**Stratham Planning Board Meeting Minutes**  
**August 15, 2018**  
**Municipal Center, Selectmen's Meeting Room**  
10 Bunker Hill Avenue  
Time: 7:00 PM

- 118  
119 c. **Subdivision Regulation Amendments.** Stratham Planning Board is proposing to  
120 rescind and replace *Addendum A: Road Design & Construction Specifications* of the  
121 Subdivision Regulations.

## ADDENDUM A: ROAD DESIGN & CONSTRUCTION SPECIFICATIONS

FIGURE A — ROAD CROSS SECTION

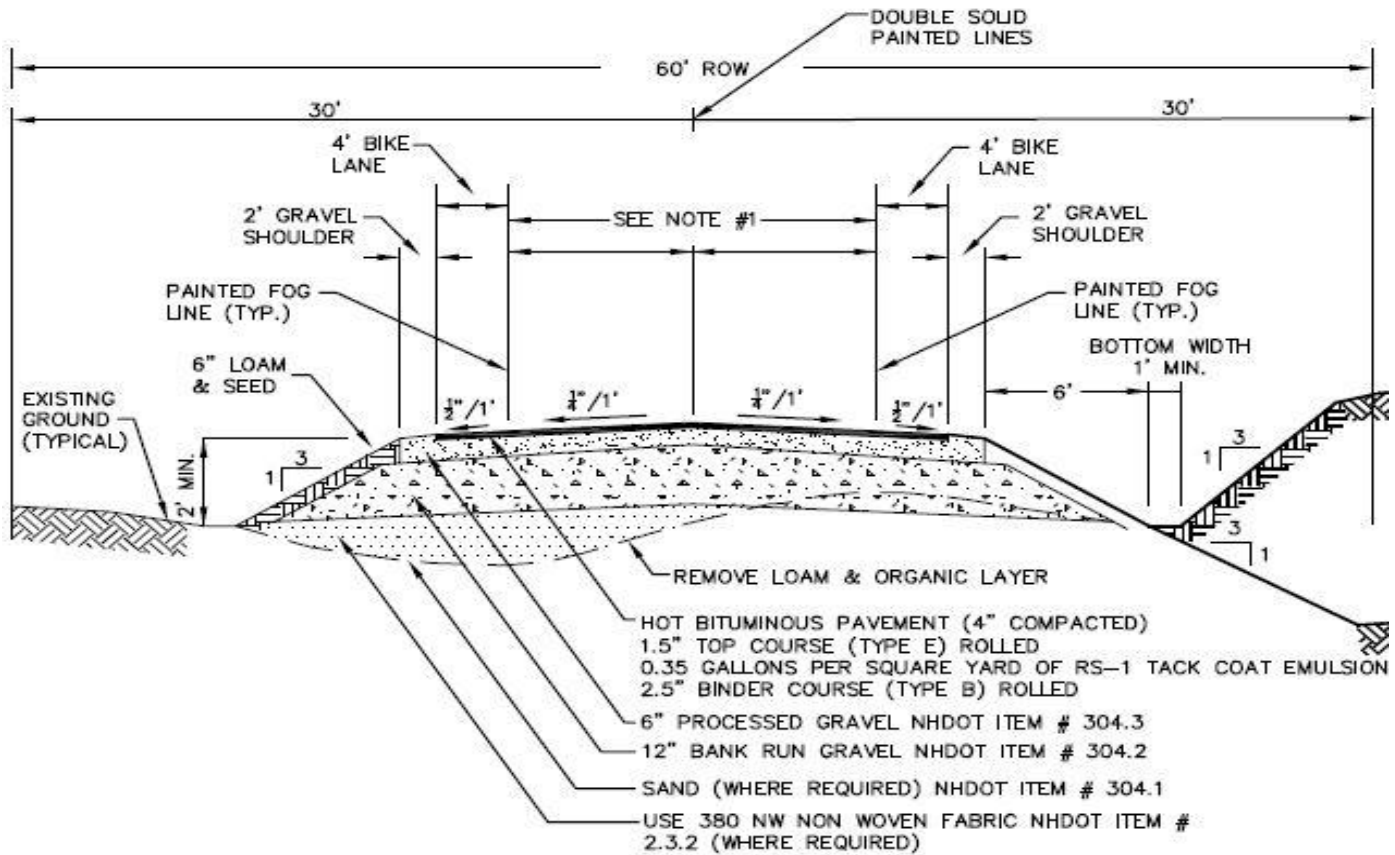
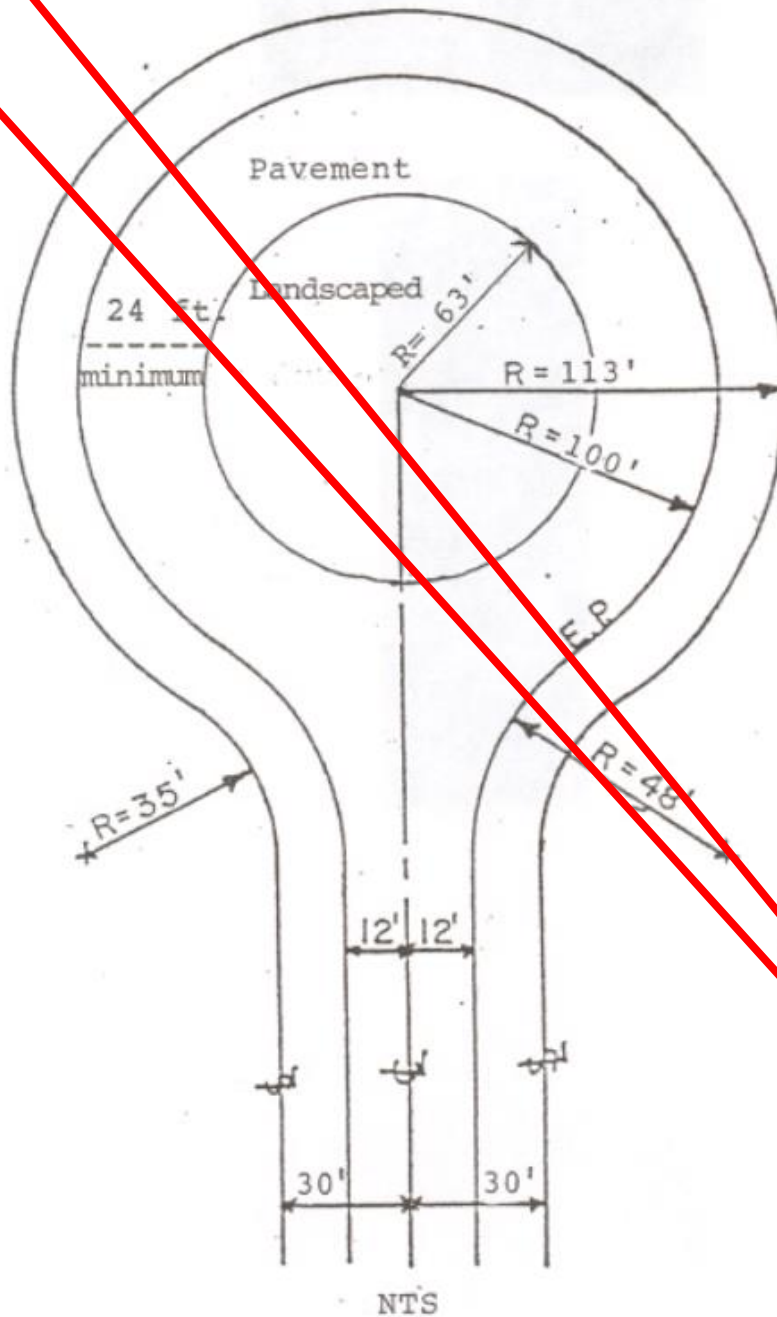
127  
128 Mr. Austin stated the majority of errors/corrections are Scribner errors, completion of the  
129 table, and modifying the "cross section".

1. PAVEMENT WIDTH TO BE 28' (INCLUDING BIKE LANES), 22' FOR RESIDENTIAL DEAD END ROADS.
2. ALL MATERIALS TO BE INSPECTED, TESTED, AND APPROVED BY DEPARTMENT OF PUBLIC WORKS.
3. ALL CROSS CULVERTS SHALL BE HDPE PIPE WITH A 12" MINIMUM DIAMETER AND A 3' MINIMUM COVER.
4. UNDERDRAINS SHALL BE INSTALLED WHERE REQUIRED BY PUBLIC WORKS.

FIGURE B – TYPICAL DETAIL PAVED TURNAROUND

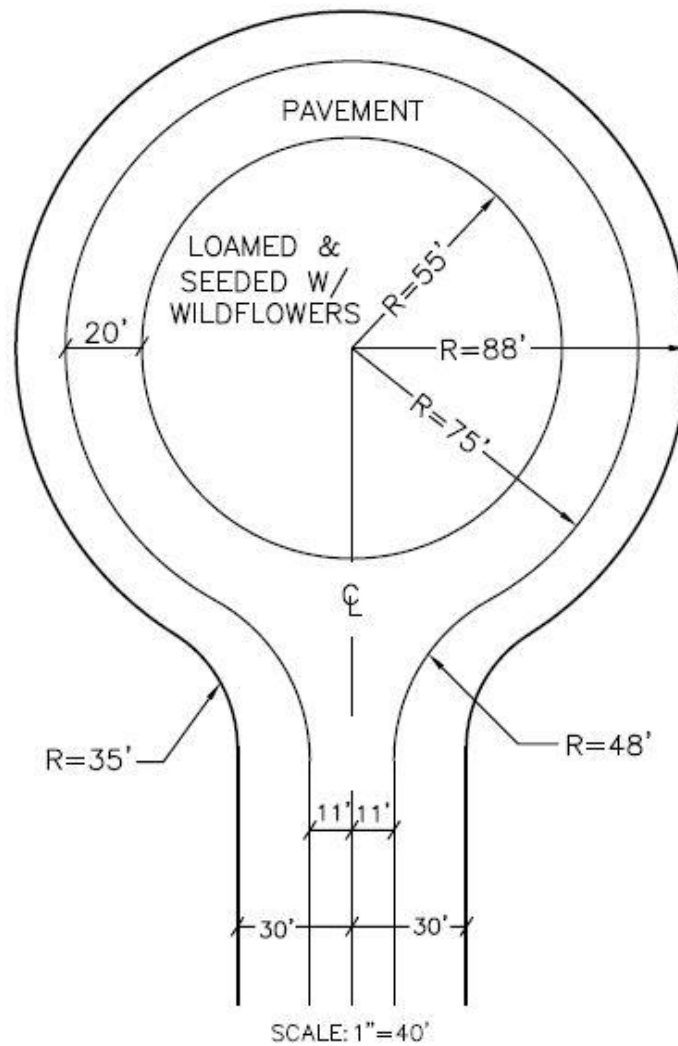
1. 20' PAVEMENT IN CUL-DE-SAC CROWNED AT TYPICAL 1/2" / 1' WITH 4' GRAVEL SHOULDER ON BOTH SIDES.

FIGURE C – TYPICAL DETAIL TEAR DROP TURNAROUND

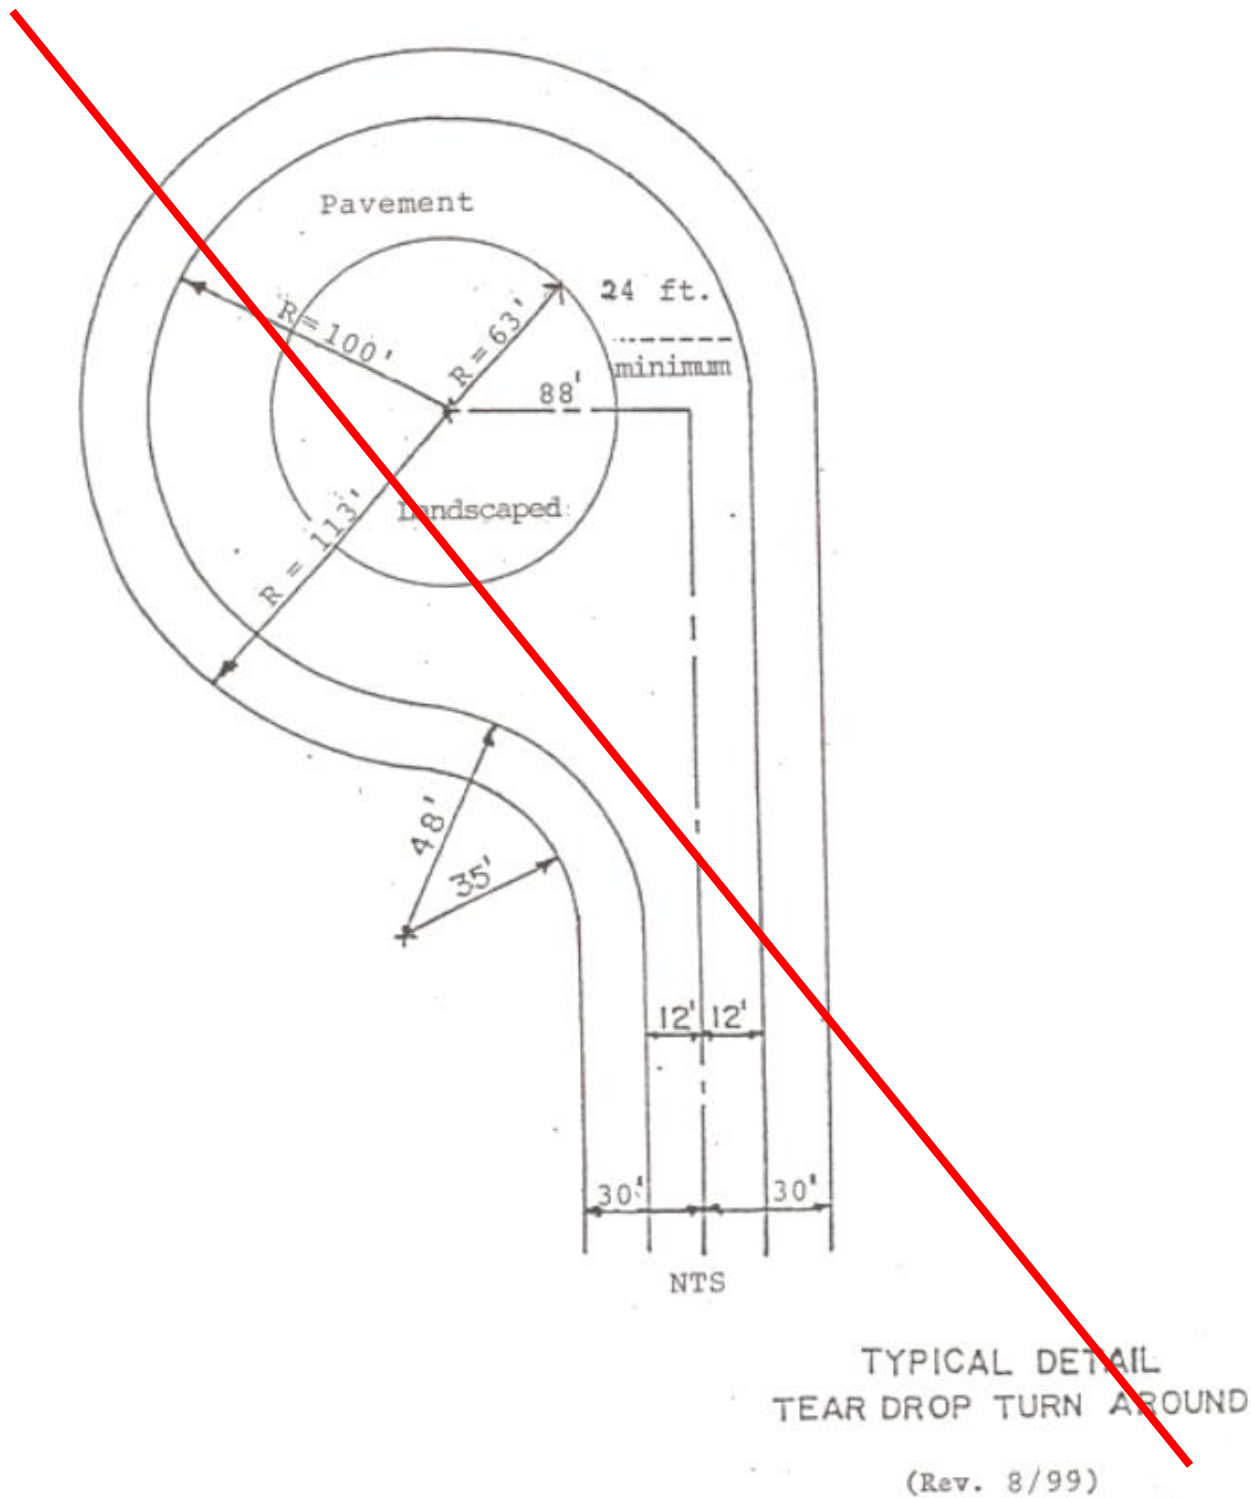
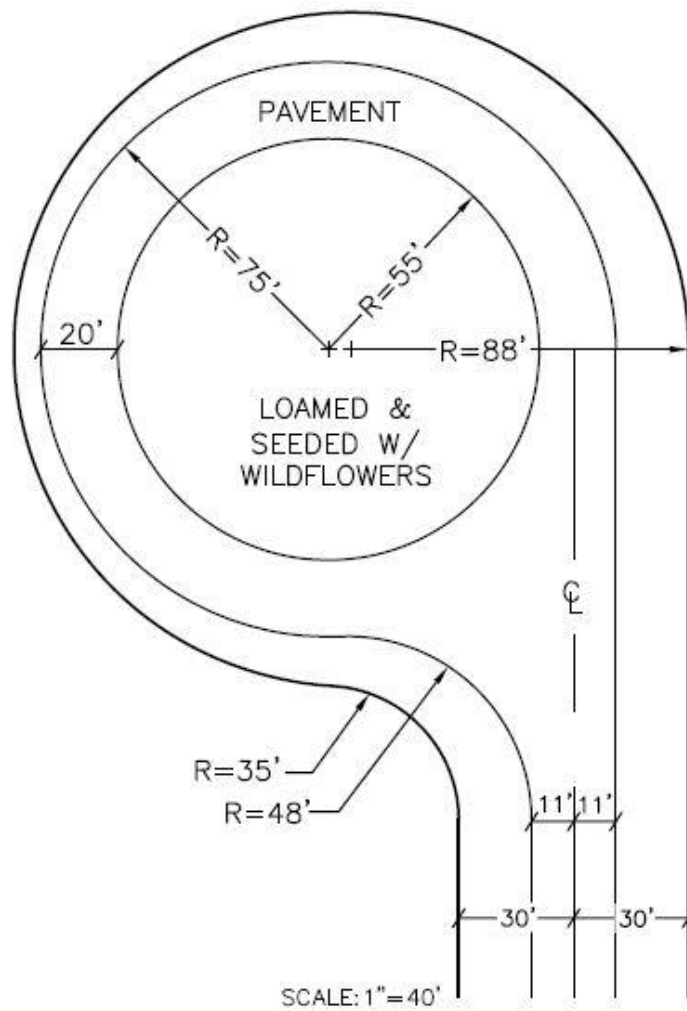
1. 20' PAVEMENT IN CUL-DE-SAC CROWNED AT TYPICAL 1/4"/1' WITH 4' GRAVEL SHOULDER ON BOTH SIDES.
